STAFF REPORT: OCTOBER 8, 2025 MEETING PREPARED BY: E. THACKERY

APPLICATION NUMBER: HDC2025-00577 **ADDRESS:** 19219 WARRINGTON DRIVE

HISTORIC DISTRICT: SHERWOOD FOREST HISTORIC DISTRICT

SCOPE: REMOVE EXISTING WOOD ROOF SHINGLES AND REPLACE WITH ASPHALT ROOF ON

19219 Warrington Drive, front (east) façade, north side, and garage, September 2025, staff photo. Wood shingle roof evident on both house and garage.

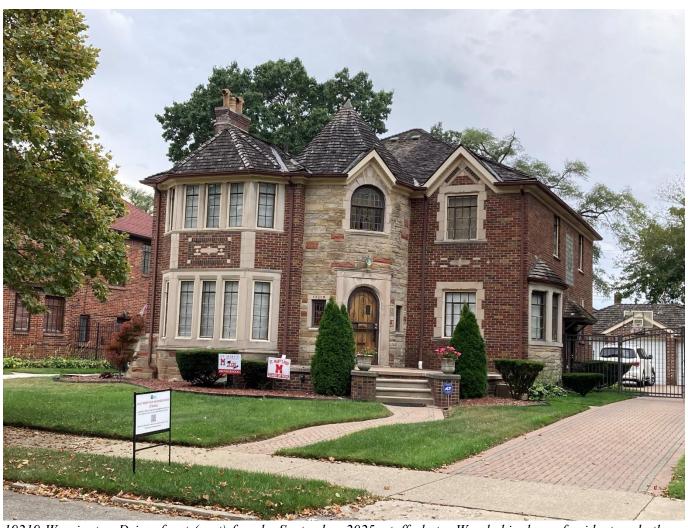
- Both the house and garage contribute to the historic district and both are currently covered in wood shake roofing, which is a distinctive and historic character-defining feature of the resources.

- Applying Secretary of the Interior's Standards for Rehabilitation #6, staff does not find that the asphalt roof proposed for the house and garage is a close enough visual match for the existing wood shake roofing in design, color, texture, or materials to meet this Standard.

Recommendation 1 of 1, Denial

Staff recommends that the proposed work will <u>be inappropriate</u> according to the Secretary of the Interior's Standards for Rehabilitation and the Sherwood Forest Historic District's Elements of Design, specifically:

19219 Warrington Drive, front (east) façade and some of the north side visible, September 2025, staff photo. Wood shingle roof evident on both house and garage.

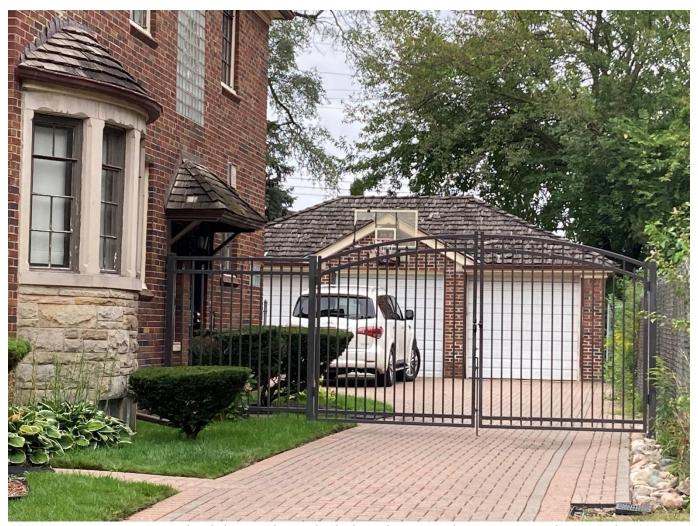
- Both the Elements of Design and the designation report state that it is significant in the district that garages relate to the primary house on the lot; the garages must take their cues from the materials, colors, and architectural styles used on the main house. As a result, whatever roofing material is selected at this property, both the house and the garage must be roofed with the same material.
